FAIRFIELD RESIDENTIAL

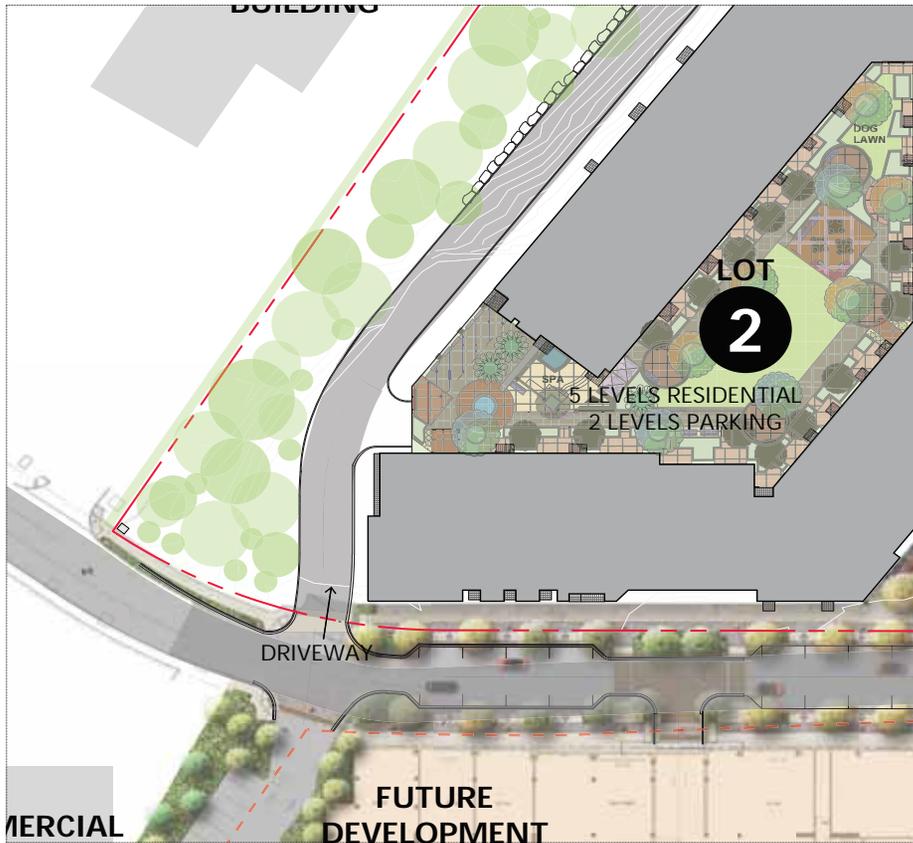
At the northwest corner the wedge shaped element is also showing a dead end at the fire access road. If this area is for loading it does not seem an appropriate use. The Design Team needs to further study this area as it should complement Phase 1 and act as a gateway on 120th Street. Also the DRB is not sure about the metal corner and driving under an oddly angled port-cochere.

The northwest corner has been restudied and the fire access driveway under the building has been eliminated to better define a gateway corner into the project. The architecture at the corner has been articulated to truly define a gateway and better relate to the architecture of Phase 1

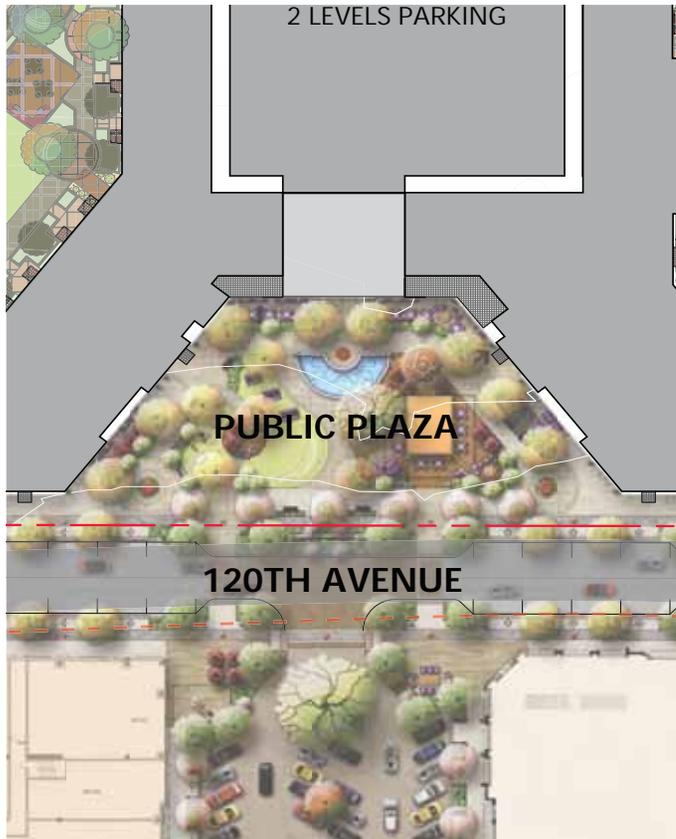
The conceptual master plan calls for a focal element at the main plaza. At this time no hierarchy is shown in the plaza concept. In previous versions the plaza was a grand plaza but now it is broken up with too many different elements. Need more information on the proposed program in this area, the main water feature and how materials from Phase 1 translate to Phase 2.

Revised plaza plans and renderings better reflect the proposed program and clearly show the various components of the plaza. Enhanced materials are used throughout the building elements facing the plaza. The architecture and the expression of accent elements complements the overall plaza concept.

STONE TILE PALETTE

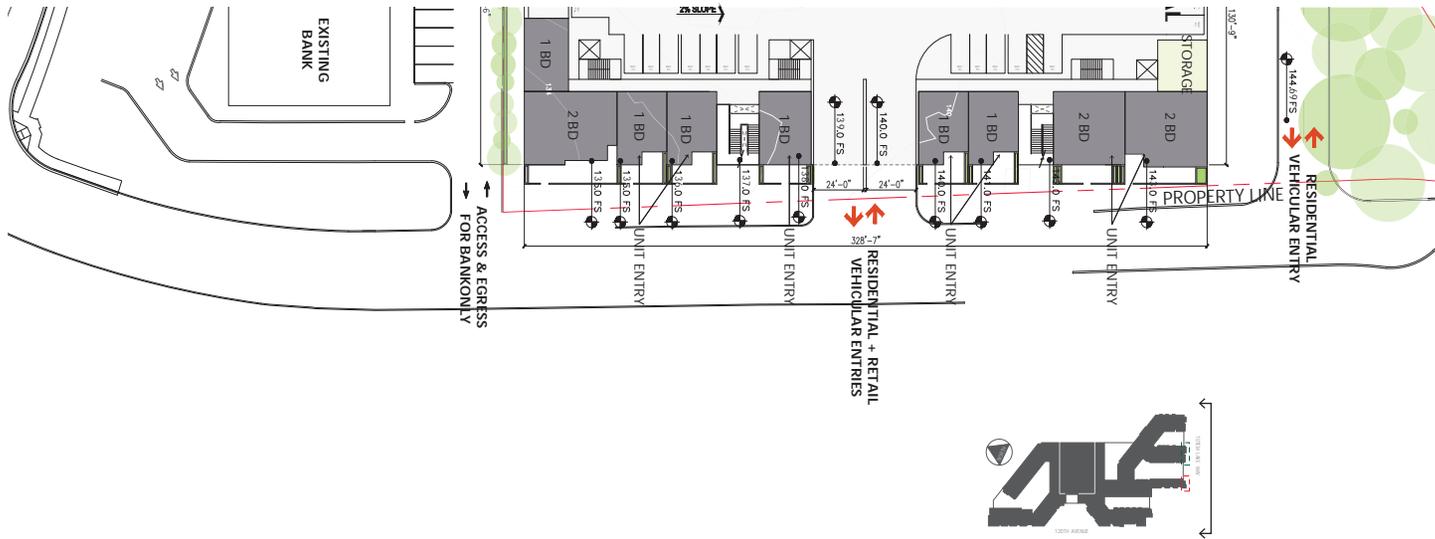
The material selections for the project with an extensive use of hardie board is of concern. The execution of a material like hardie board is very critical as well as the modulation whether siding or larger panels are used. The DRB would prefer hardie board only be used sparingly and for other materials like terracotta and tile to be considered. The approach of using different materials in the same color right next to each other is not successful and should be further evaluated. The industrial nature of the use of metal is welcomed and should be expanded. Brick on a larger scale should be used with caution. Also renderings show the window system in a dark color rather than a white typical of vinyl windows. Need clarification.

The use of hardie board is now limited to the courtyard facades and the façade facing the fire access road. Use of tile has been introduced and the use of brick has been expanded as well as metal panel to replace previously shown hardie board. All proposed materials are represented on a materials board.
